UNITED STATES PATENT AND TRADEMARK OFFICE

APPLICATION NO.	FILING DATE	FIRST NAMED INVENTOR	ATTORNEY DOCKET NO.	CONFIRMATION NO.
09/426,111	10/22/1999	J. ROBERT MITCHELL	10991572-1	1439

# Office Action Summary

### DETAILED ACTION

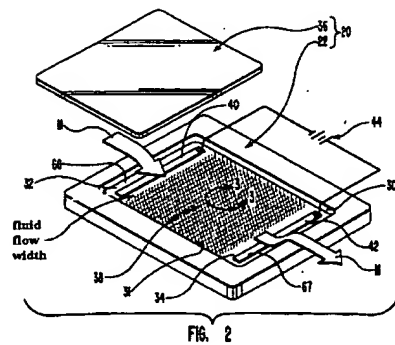
Austin *et al* teach a package for performing sorting and viewing multiple features on a substrate 22. The package comprising a housing 24 having a chamber 34 formed by the housing and the substrate. The chamber is accessible through a first port formed by the side walls 30, 31 and the coverslip 36, see loading area 66 (Figs. 1-2). The housing including a first set of multiple fluid distribution channels 54 disposed between the first port and the chamber. Additionally, Austin *et al* teach adding fluid through the first port such that fluid flow is directed by the multiple fluid distribution channels between the multiple different regions across the first side of the received substrate from the first port. Moreover, Austin *et al* disclose wherein all of the channels, formed by baffles, are micro- or capillary sized (column 11, lines 20-55, Fig. 4). The substrate can be exposed to irradiation, light illumination, etc. (column 23, lines 1-65). Note: it is well-known within the art that channels 10 microns in diameter exhibit capillary action to retain fluid. Additionally, the fluid flow width increases between the first port and the first set of distribution channels, see modified Figure 2 below, where Examiner has clearly marked the expansion area between the loading area 66 and the first set of distribution channels.

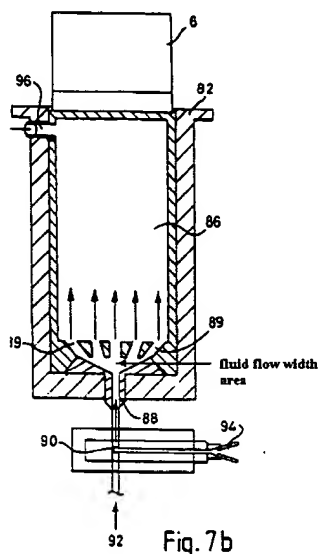
Additionally, Freeman does show the fluid flow width increasing between the first port and the first set of distribution channels see modified Figure 7b below, where Examiner has

clearly marked the expansion area between the loading area 88 and the first set of distribution channels 89.
